UNITED STATES PATENT AND TRADEMARK OFFICE

APPLICATION NO.	FILING DATE	FIRST NAMED INVENTOR	ATTORNEY DOCKET NO.	CONFIRMATION NO.
10/620,287	07/15/2003	Patrick J. Sweeney	029815-0102	7722

Office Action Summary	Application No. 10/620,287	Applicant(s) SWEENEY, PATRICK J.	
	Examiner CHRISTOPHER D. KOHARSKI	Art Unit 3763

DETAILED ACTION

FIG. 12

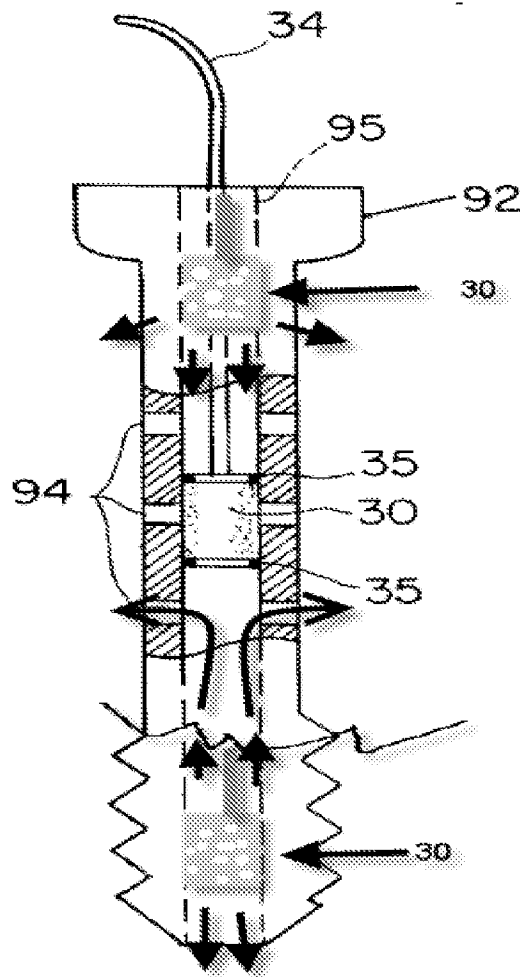
Regarding claims 1-6, 9-11, and 13-17, Spievack et al. discloses a device (Figure 12, 90) for delivering a substance to a bone, the device comprising: (a) a bone screw (92) comprising two ends connected by a shaft, wherein the shaft is cannulated along at least a portion of its length; (b) one or more bone-screw fenestrations (94) disposed along the cannulated portion of the bone-screw shaft; (c) an insert (30) disposed inside the cannulated bone-screw shaft, wherein the insert comprises two ends connected by a shaft and is cannulated (through connection 34) along at least a portion of its length; and (d) one or more insert fenestrations (sponge pores) disposed along the cannulated portion of the insert between the two ends of the insert, wherein the insert is movable between: a first position (see marked up figure below, above or below the fenestrations 94) wherein none of the one or more insert fenestrations align with the one or more bone-screw fenestrations such that the insert substantially prevents material (fluid pressure through delivery from 30) from entering the cannulated portion of the bone-screw through the one or more bone-screw fenestration; and a second position (overlying the fenestrations as shown in Figure 12) wherein the insert provides a delivery pathway for the substance between at least one end of the bone screw and the at least one bone- screw fenestration (Figure 12, cols 1-2).

Examiner asserts that the sponge member (30) of Spievack et al. can be placed at either the top or bottom of the cannulated screw to provide delivery via the sponge member (30) (without seals 35, see col 6, ln 1-20) in order to provide a positive fluid pressure which will prevent material from entering the bone screw body (see drawing next page).
